**Analysis and critical review of Monte Carlo simulation and
decision analysis in EPA's 2014 RFS proposed rule**

Prepared for the American Petroleum Institute

Professor Robert T. Clemen
January 16, 2014

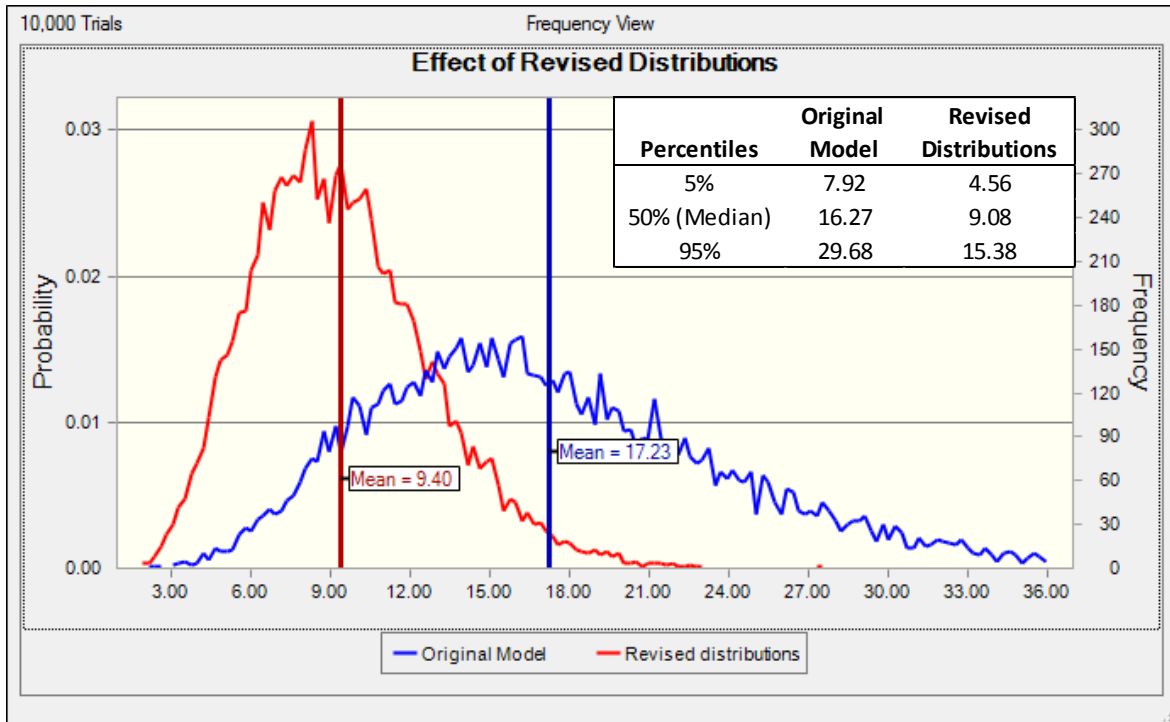
362 The cellulosic biofuel model suffers the most from the problem that $P(\text{Vol}=0)$ was not
363 carefully specified for the individual producers. As it stands, five producers with approved
364 pathways were considered. Of these, Abengoa, DuPont, KiOR, and Poet all have 5th percentiles
365 equal to zero, which, given the way the model was implemented, implies that $P(\text{Vol}=0) = 5\%$ for
366 each of these producers. In contrast, CoolPlanet, Fiberight, LanzaTech, and Sweetwater were
367 considered and excluded from the model on the grounds that none are considered in a position to
368 produce any cellulosic biofuel in 2014. INEOS Bio was assigned a skewed distribution, and the
369 minimum volume that distribution can generate is 1.71 million gallons, implying $P(\text{Vol}=0) = 0\%$.
370 So we have a situation where one producer is deemed certain to produce at least 1.71 million
371 gallons, four are judged to have a 5% chance of producing nothing, and four are judged to have a

372 100% chance of producing nothing. In my opinion, this is not a satisfactory way to model the
373 uncertainty associated with new technology and start-up firms. Surely there are aspects of the
374 various enterprises that would indicate a finer distinction in terms of the likelihood of producing
375 no cellulosic biofuel at all.

376 If the modeling suffers from the $P(\text{Vol}=0)$ problem, it is to a large extent relieved by the
377 fact that Abengoa accounts for fully 72% of the variance in the aggregate total. In a distant second
378 place is KiOR at 17%. What this implies is that Abengoa is the firm to focus on in terms of
379 refining the probability judgment. However, relatively modest changes in Abengoa's distribution

380 can result in meaningful changes in the aggregate distribution. For example, in the original model,
381 the median aggregate output is 16.27 million gallons. Dropping Abengoa's 95th percentile from 18
382 million gallons to 16 million, an 11% decrease, results in the median aggregate output dropping to
383 15.71 million gallons. If in addition we increase Abengoa's $P(\text{Vol}=0)$ from 5% to 20%, the
384 median drops further to 14.62 million gallons. These two small changes in Abengoa's distribution
385 have resulted in the median aggregate output dropping by over 1.6 million gallons, a 10% change.
386 Noticing this effect that Abengoa can have on the results suggests that additional care be given to
387 assigning Abengoa's probability distribution.
